JOURNAL OF COASTAL AND HYDRAULIC STRUCTURES

Review and rebuttal of the paper

Decay of bow thruster induced near-bed flow velocities at a vertical quay wall: A field measurement

Tukker et al.

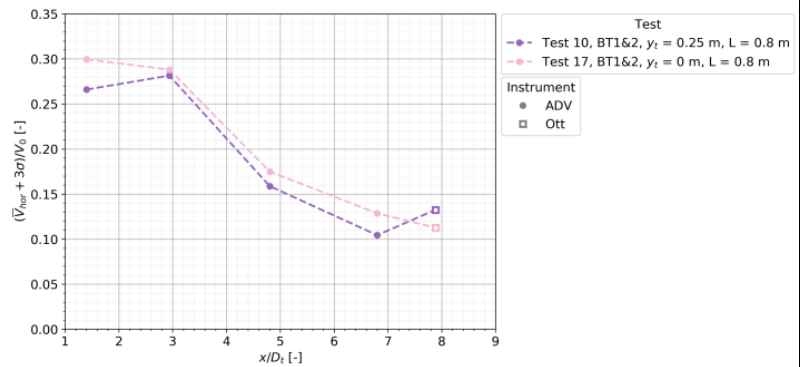
“during”? Is it to imply measuring transient processes or stationary processes? If the latter, these are simply further test runs, right?	L193: <i>“The second parameter that was altered is the used bow thruster.”</i>
26	L164: Make sure to use italics for symbols, variables, and other math stuff.	Adjusted throughout the paper.
27	L175: All math symbols should be formatted italic	Adjusted throughout the paper.
28	L176: Please comment on the repeatability of all tests, in particular on the manoeuvring testing? How did the authors make sure that these tests were consistent in time and space?	A few tests with the same or similar parameters were repeated showing similar flow velocities. This was for BT2 Test 5 and Test 8 (same parameters) during the 25% and 90% power step and for BT1&2 Test 10 and Test 17 (having a difference in Δy of 0.25 m) during the 50% power step. The results are shown below which are from (Tukker, 2021) the master thesis were the measurements used for this paper are discussed more elaborately.  Figure 7.1: Comparison Test 5 and Test 8 at 25% and 90% power.

Leading to a very similar velocity decay profile and a relative difference in maximum flow velocity ($\bar{V}_{hor} + 3\sigma$) of:

25%	23.03%
50%	11.68%
90%	29.48%

Leading to an average of 21.4%.

"To ensure repeatability and consistency, the tests were conducted at a location with negligible flow and no other vessels present, within a short two-day period under constant environmental conditions. Two pairs of tests (Test 5 and 8, and Test 10 and 17) were repeated under nearly identical conditions. The average relative difference in maximum velocity ($\bar{V}_{hor} + 3\sigma$) was found to be 21.4%."

Figure 7.2: Comparison Test 10 and Test 17 at 50% power.

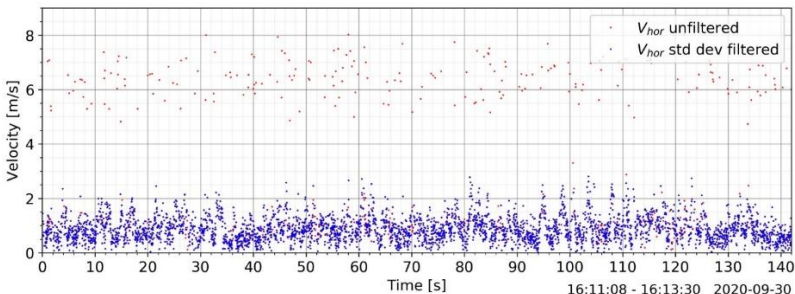
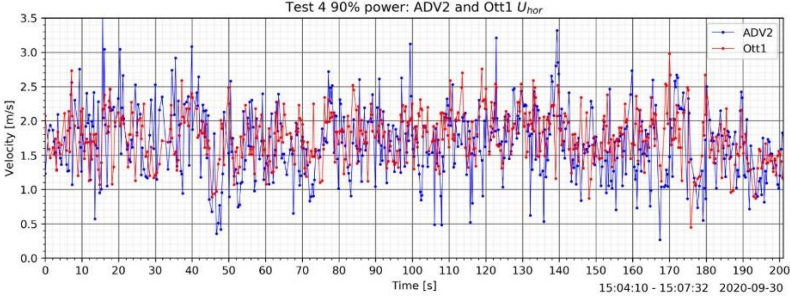
According to Test 10 in Table 3, which involved both active bow thrusters (BT1 & BT2), there is also a Δy value of 0.25 m. This is despite the fact that the text states that for tests with $\Delta x = 3$ m and 5 m, the measurement frame was positioned with an offset of $\Delta y = 0.25$ m. However, Test 10 is listed among the tests with $\Delta x = 0.8$ m, not 3 m or 5 m. This discrepancy should be clarified or corrected in the text.	Test 10 did not). Therefore, no further analyses was done for Test 10 with $\Delta y = 0.25$ m. L244-249: <i>“Not every power step is measured for each test due to the instability at 50% power for BT2. Additionally, time constraints led to a focus on the 50% and 90% power steps, as these are assumed to produce the highest hydraulic loads on the bed. Several tests are excluded from further analysis: Test 1, a long measurement to determine the minimum duration for a stable flow velocity; Test 5, which is identical to Test 8 but with slightly lower measured velocities; Tests 6 and 7, which focused on load cell measurements not considered in this study; and Test 10, which was aborted after the 50% power step. “</i> Additional figure comparing Test 10 and Test 17 during the 50% power step:
